2001 S. 1ST STREET

2001 S. 1ST STREET
SP-2018-0017C

*Environmental Review Specialist Senior
Development Services Department*

SP-2018-0320DS

PROPOSED SITE PLAN

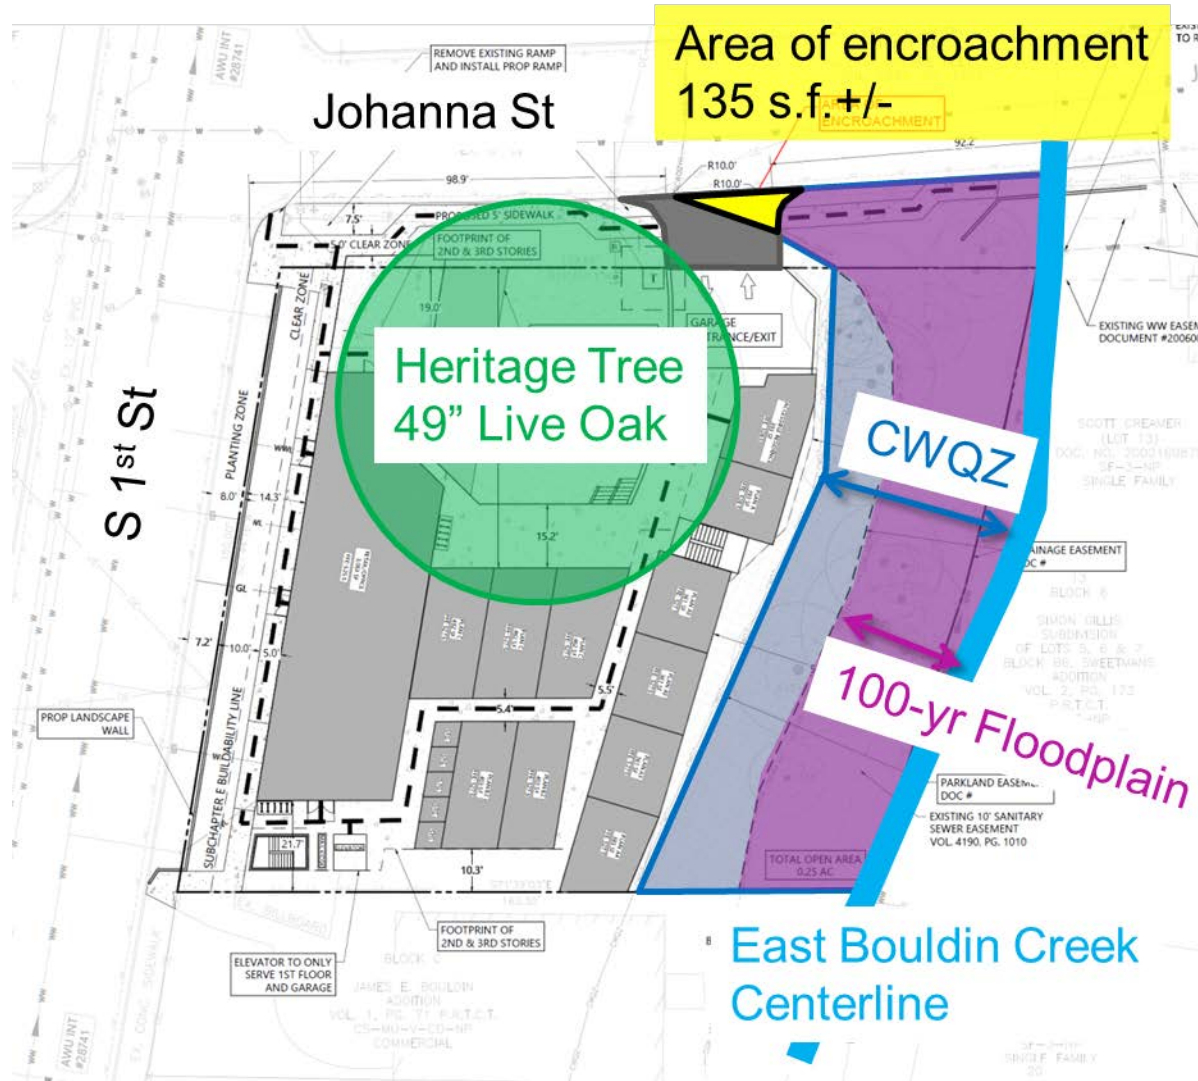
**LDC 25-8-261 prohibiting development in a
Critical Water Quality Zone.**

To allow a portion of the driveway to be constructed in the Critical Water Quality Zone.

Determination of staff is that the request meets the findings of fact stated in LDC 25-8-41

- with the following condition:
 - applicant work with Wetland Biologist reviewer to provide enhanced CWQZ improvements.

TREE PRESERVATION

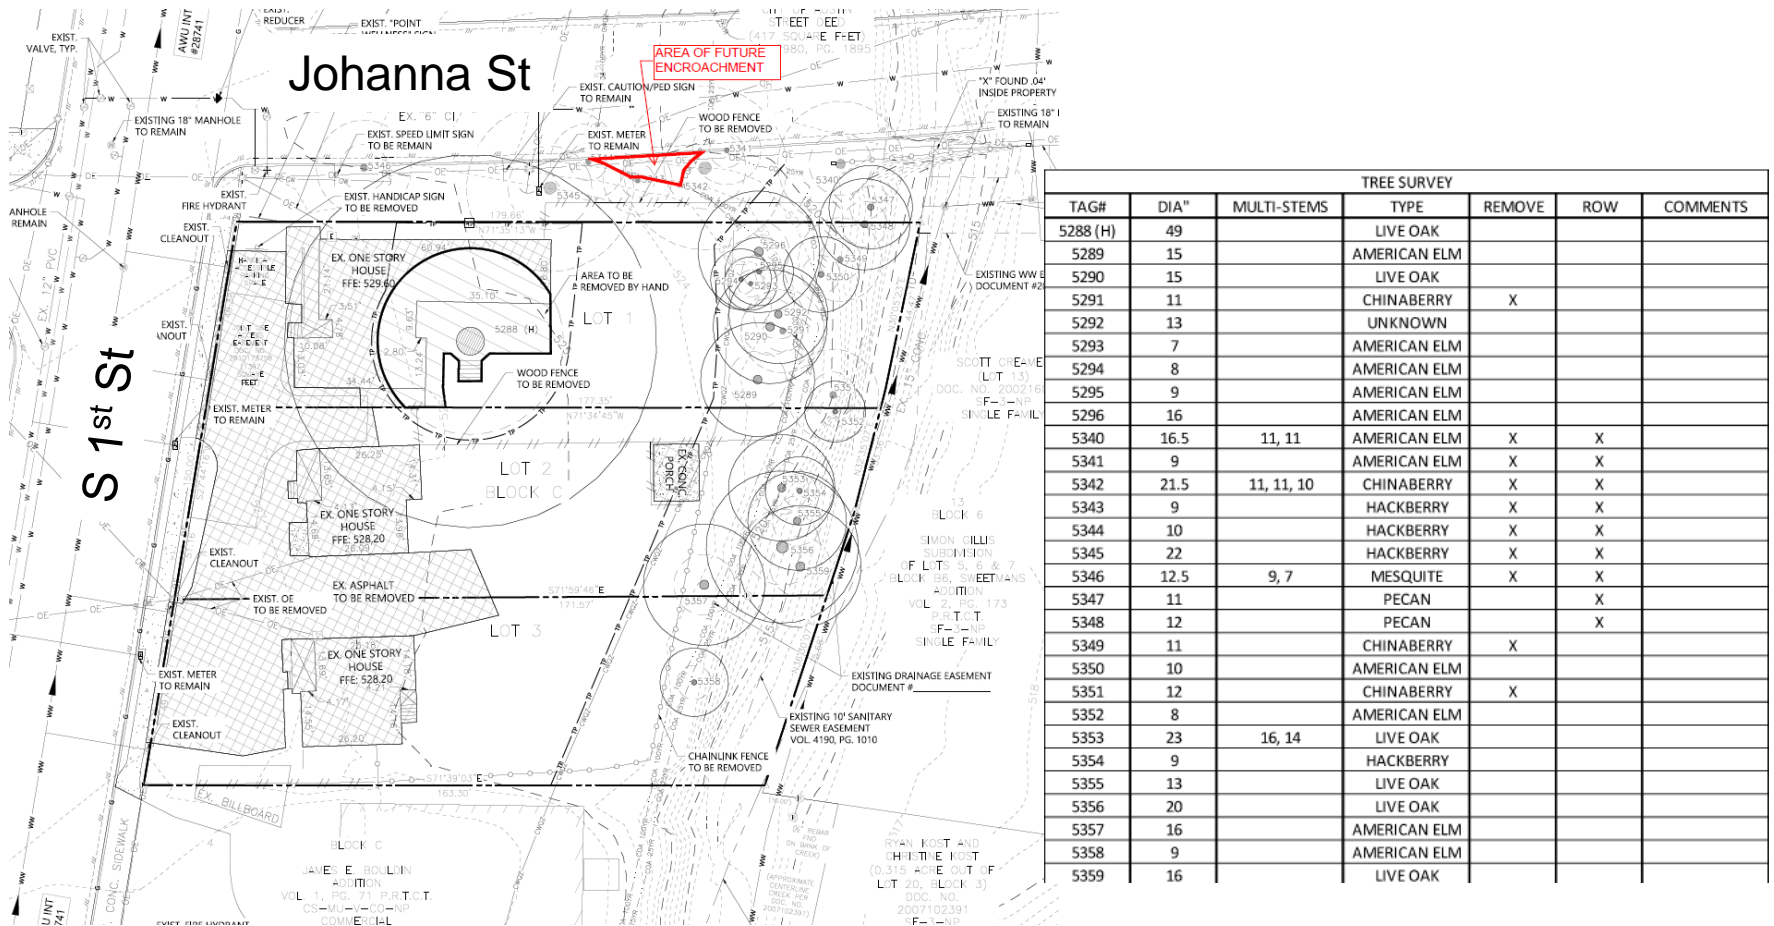
All trees will be preserved, except for right-of-way trees that must be removed for sidewalk.
